A HIGH-RISK PROPOSAL

DRILLING THROUGH THE BLUE RIDGE MOUNTAINS

FOR THE ATLANTIC COAST PIPELINE

Comments to the Federal Energy Regulatory Commission
Docket CP15-554
Submitted on behalf of the Dominion Pipeline Monitoring Coalition
Rick Webb, Program Coordinator

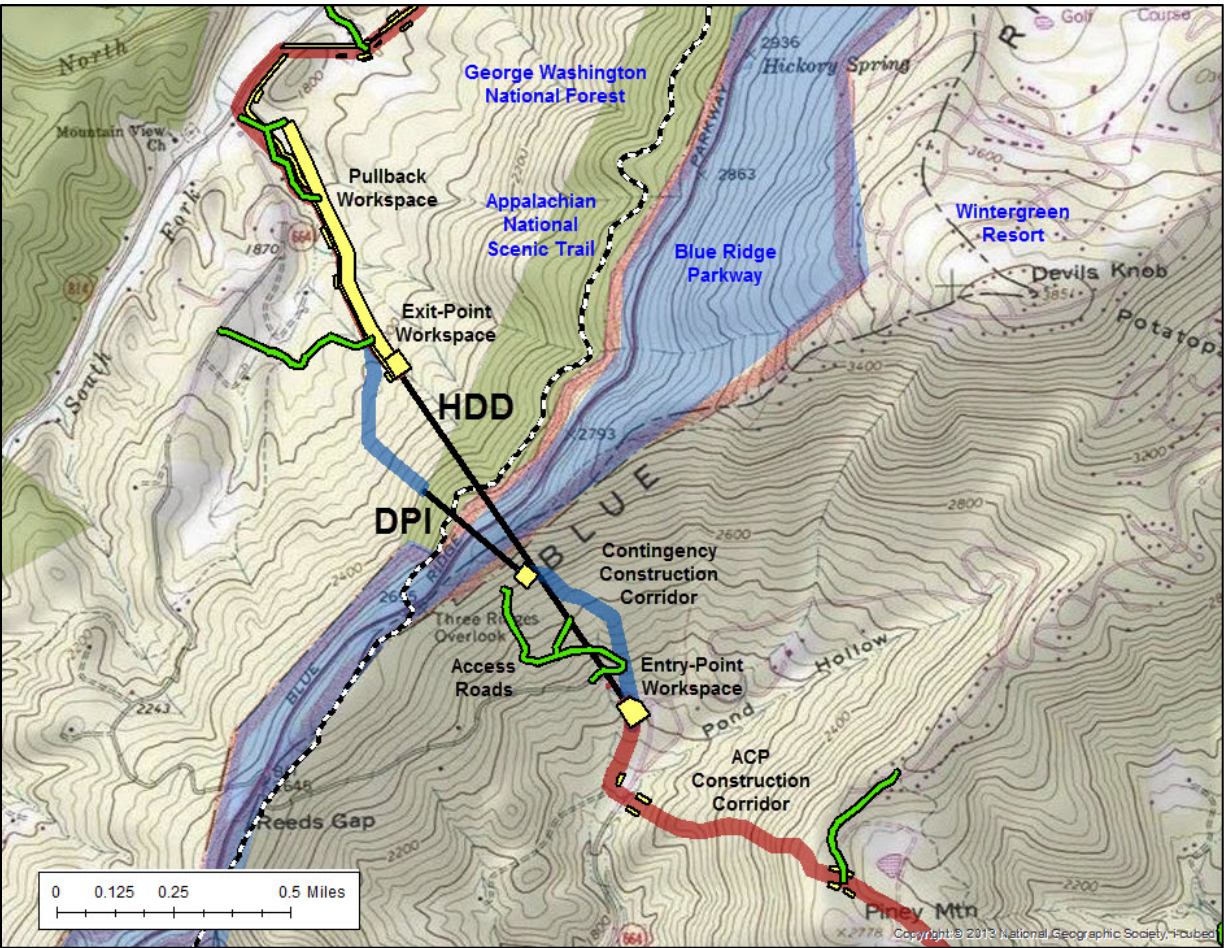
Because of restrictions on construction of a utility corridor across the Appalachian National Scenic Trail (ANST), Dominion proposes to tunnel through the Blue Ridge using horizontal directional drilling (HDD). Another drilling method, direct pipe installation (DPI), is proposed as a contingency should the HDD operation fail.⁴ A map depicting the proposed HDD and DPI drill paths, workspace, pipe pullback areas, and access roads is provided as **Figure 1**.

the information that Dominion provided for consideration in the DEIS analysis is incomplete and misleading. It does not support an objective evaluation of the proposed drilling operations with respect to either the potential for successful completion or the acceptability of associated environmental damage.

FIGURE 5 – Extreme pullback required for the proposed Blue Ridge HDD.

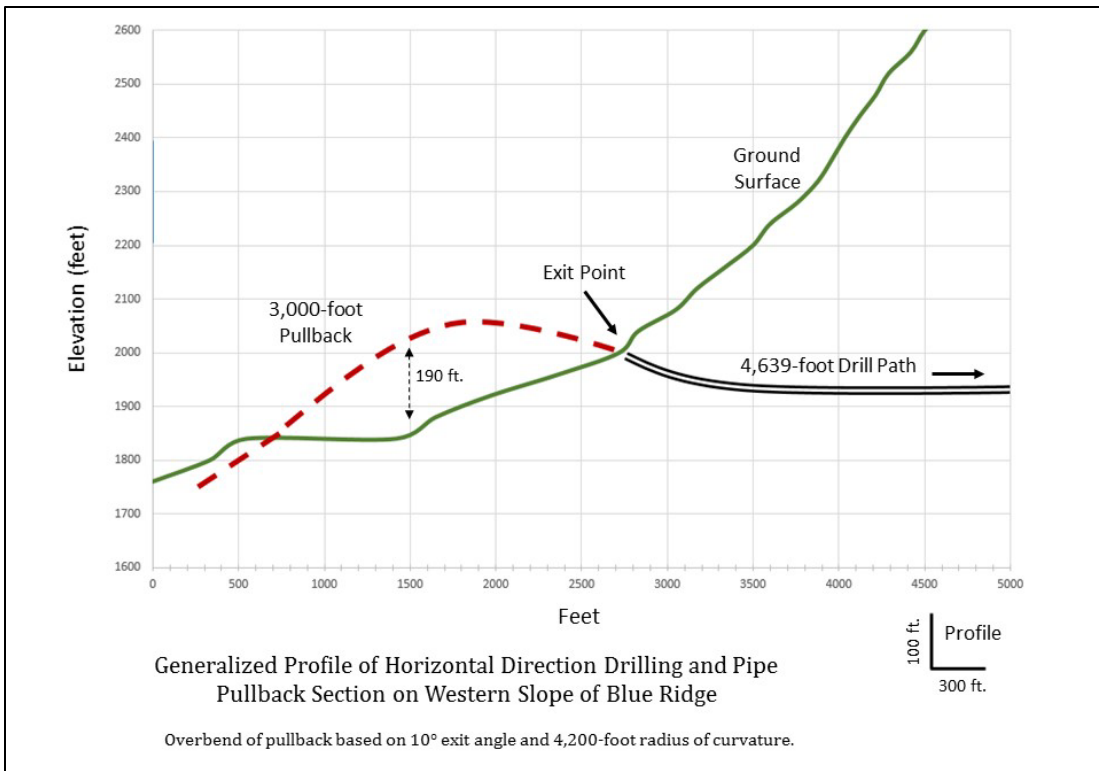
The contingency DPI installation, which would occur on even steeper slopes than the proposed HDD operation, also raises questions about the potential footprint of the staging and fabrication area and the need for pipe suspension.¹³

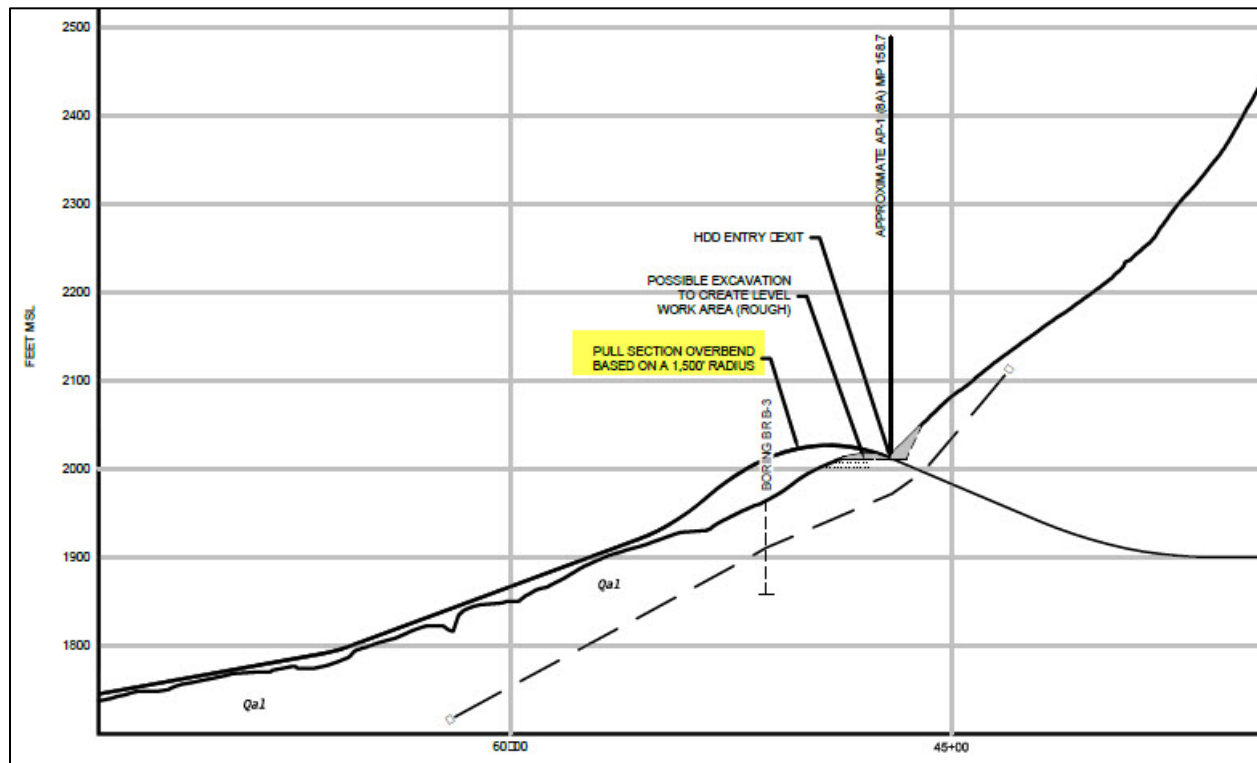
The fact that the suspension of pullback pipe and the magnitude of the related footprint were not addressed in the DEIS may be due to incorrect or misleading information provided to FERC by Dominion. The only depiction of the HDD pullback section included in Dominion submissions to FERC is based on a 1,500 feet bending radius (see **Figure 7**). This differs substantially from

the correct 4,200-foot bending radius. As indicated in the depiction, a shorter bending radius would require much less lifting of the pipe. The necessary elevation would only be about 50 feet compared to about 200 feet for the longer correct bending radius. The length of pipe suspension would also be much less. Dominion has acknowledged, but only in general terms, that there are topographic complications that affect the pullback operation.

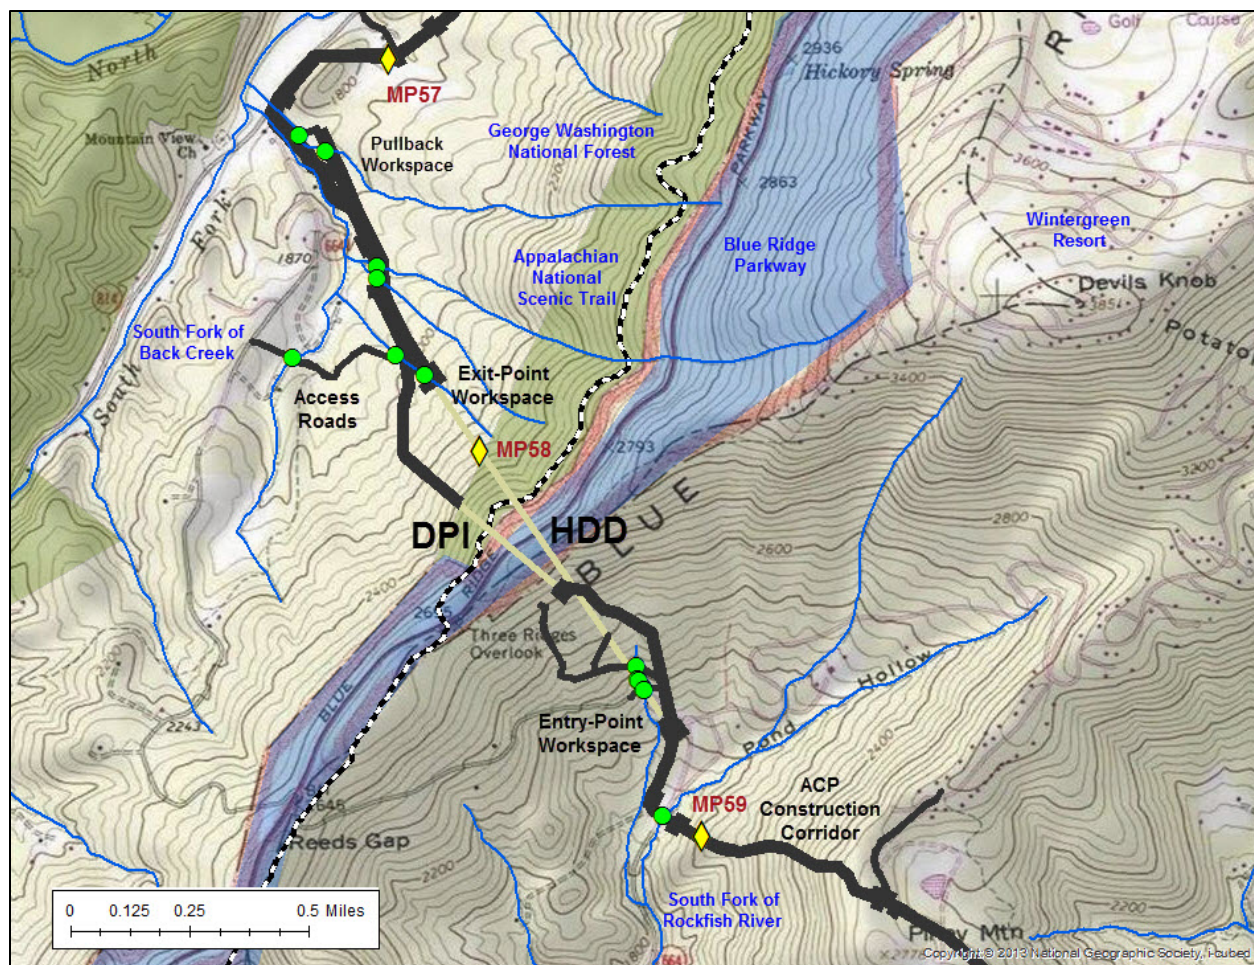
The indicated time-of-year restrictions for these streams limits work from October 1 to March 31 to protect sensitive life stages of aquatic life (see **Section 5.1**). Adherence to time-of-year restrictions conflicts with Dominion’s plans for wintertime construction.

Information submitted by Dominion to the National Park Service does not correlate with the stream crossing information depicted in **Figure 8**, nor does it reflect a pro-active approach to stream protection.¹⁶ Among a series of questions concerning the HDD operation, the National

FIGURE 9 – Recommended exit-side and pullback pipe fabrication workspace.

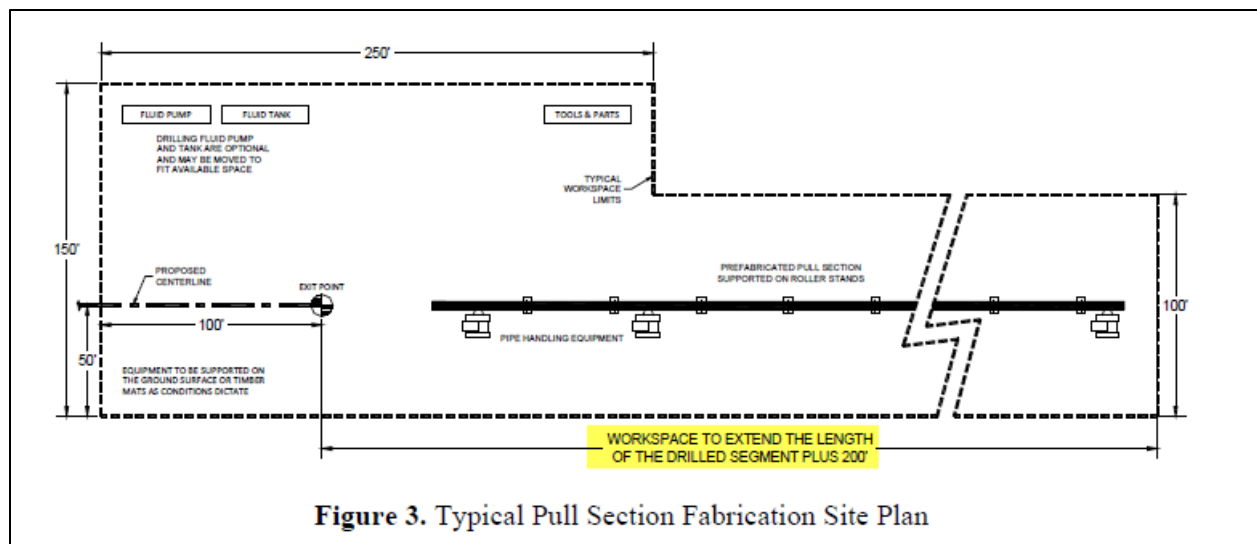
The HDD design report prepared for Dominion by J.D. Hair & Associates, Inc. includes the following statement on pullback workspace requirements:

*It is preferable to have workspace aligned with the drilled segment extending back from the exit point the length of the pull section plus approximately 200 feet. This will allow the pull section to be prefabricated in one continuous length prior to installation. If space is not available, the pull section may be fabricated in two or more sections which are welded together during installation. It should be noted that delays associated with joining multiple pipe strings during pullback can increase the risk of the pipe becoming stuck in the hole. . . . A typical pull section fabrication site plan is shown in Figure 3 [see **Figure 9**]. Where possible, we recommend obtaining workspaces of similar dimensions to accommodate HDD pipe side operations on the ACP Project.*²⁰

The length of the drilled segment for Dominion’s proposed HDD is 4,639 feet. The recommended pullback segment would thus be 4,839 feet. However, as indicated in the DEIS, the length of the workspace available for staging the pipe pullback is only about 3,000 feet, which makes fabrication, hydrostatic testing, and pullback of the recommended single continuous pipe string impossible.

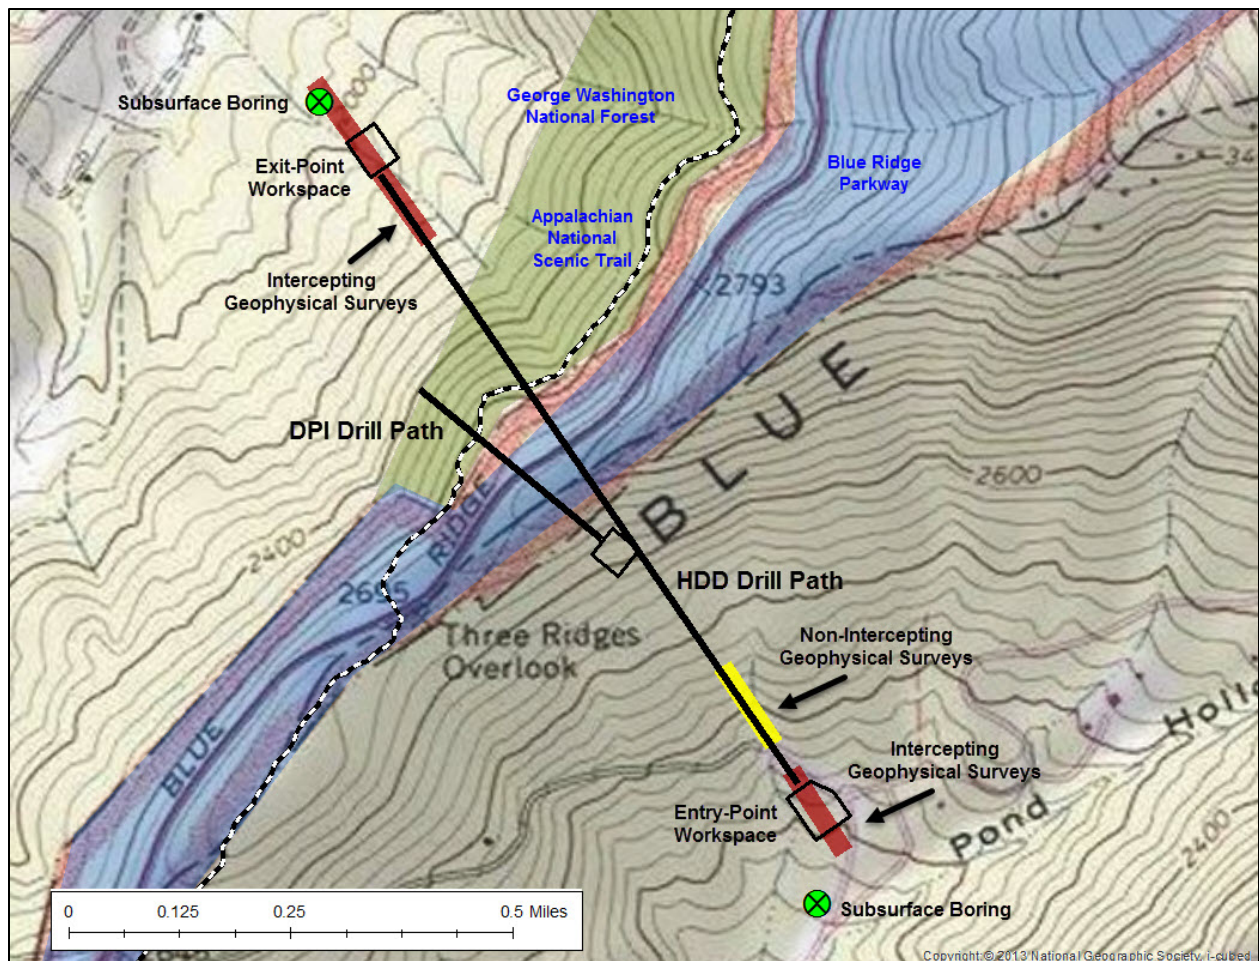
The locations of the two subsurface borings and other geophysical surveys for the HDD are indicated in **Figure 11**.

FIGURE 12 – Interpreted results of geophysical surveys conducted at the entry- and exit-sides of the proposed HDD drill path. (Based on Geophysical Study for a Proposed Blue Ridge HDD Crossing Augusta and Nelson Counties, Virginia, prepared by ATS International, Inc., 4/12/16.)

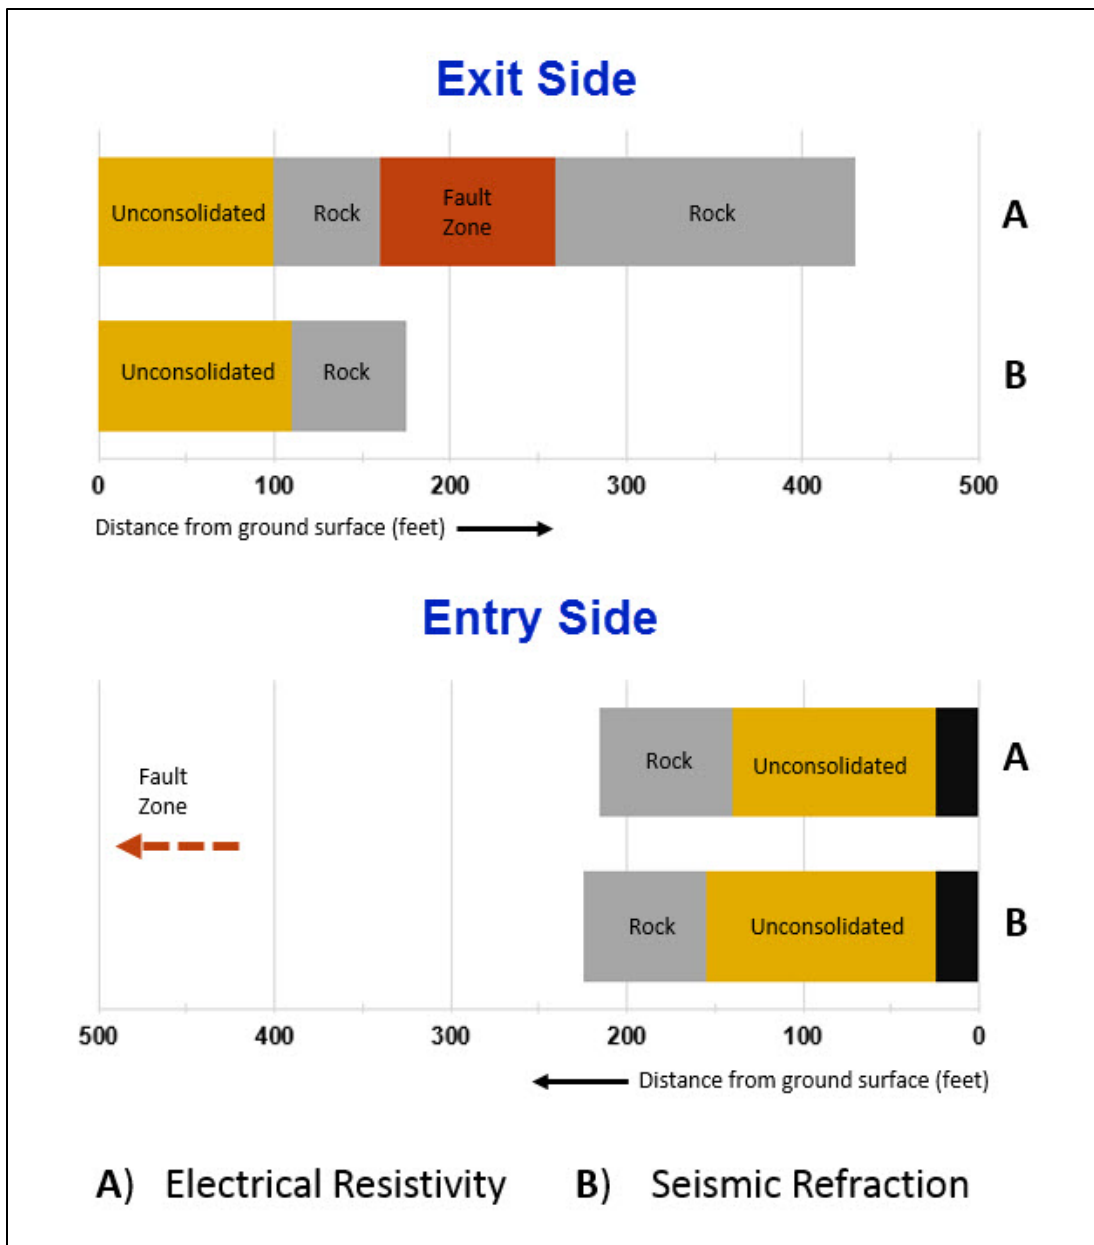
Figure 12 depicts the findings obtained through electrical resistivity and seismic refraction surveys.

In fact, the geophysical services company that conducted and interpreted the surveys raised questions concerning the reliability of even its limited findings, stating:

Results are shown for survey sections where imaging intercepted the projected drilling path. The fault zone in the entry-side section was estimated based on non-intercepting surveys, and was estimated to begin at 425-550 feet from the ground surface. The black-colored segments starting at the ground surface on the entry side indicate planned excavation. The total length of the projected drill path is 4,639 feet.

In other words, the company that performed the survey work cannot verify the accuracy of its interpretation.

FIGURE 13 – Construction-area slope and access-road grade classification for the Blue Ridge HDD and contingency DPI operations area.

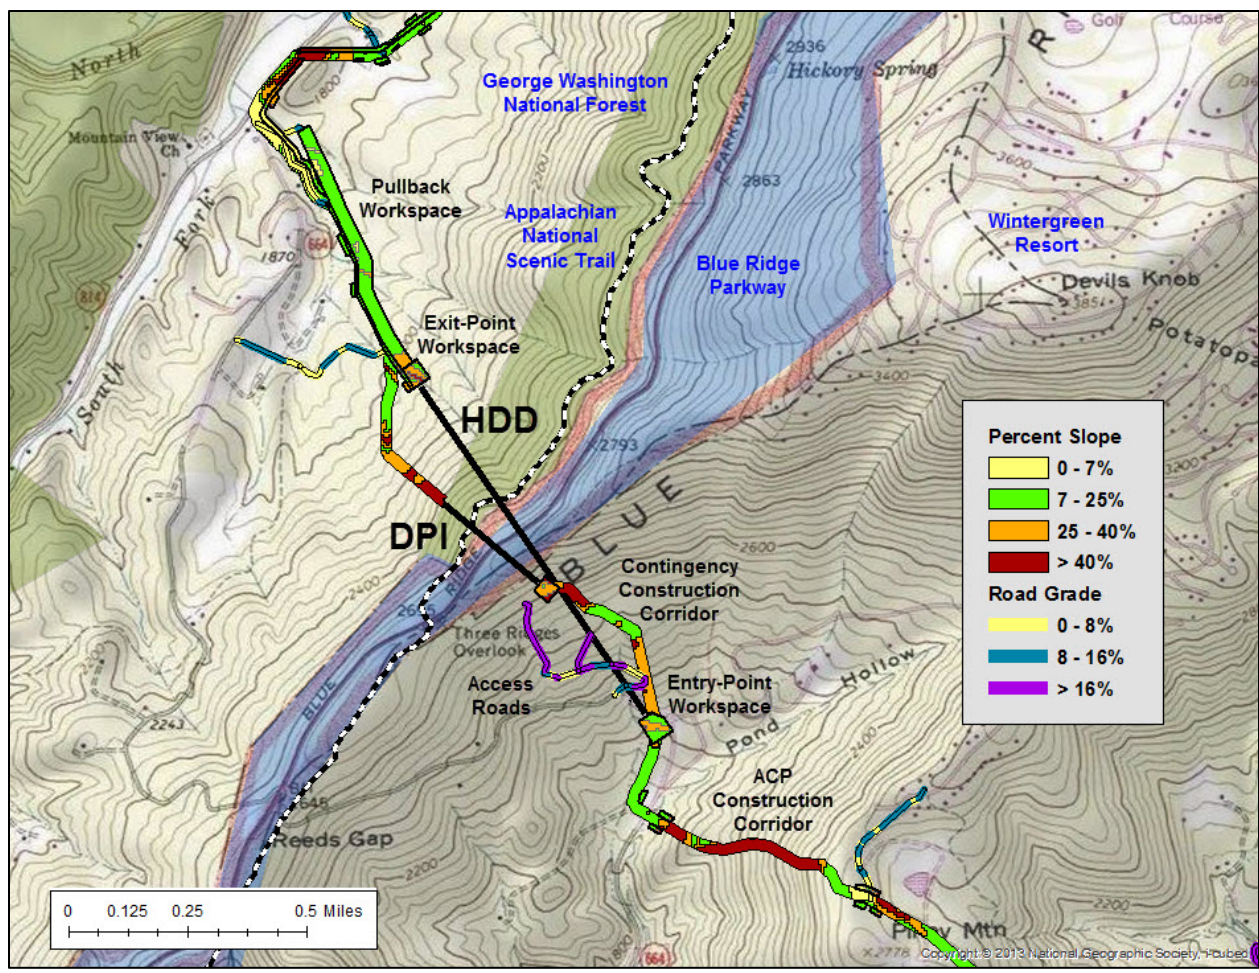
Figure 13 shows slope classes for the pipeline corridor, workspaces, pullback area, and access roads in the Blue Ridge HDD and contingency DPI areas.

Dominion proposes to wait until after completion of environmental review, until after permitting, or until after initiation of construction to provide specific plans and identify engineering solutions for the range of significant geohazard and water-related problems that confront the ACP project. This delay in planning and analysis undermines the regulatory review process, as it will not provide the agencies with the information needed for responsible permitting decisions. It also denies the public an opportunity to review and comment on the actual project.

development (see **Figure 13**). This particular access road includes a 1,300-foot segment with grades that are continuously above 25% and partly above 40%.
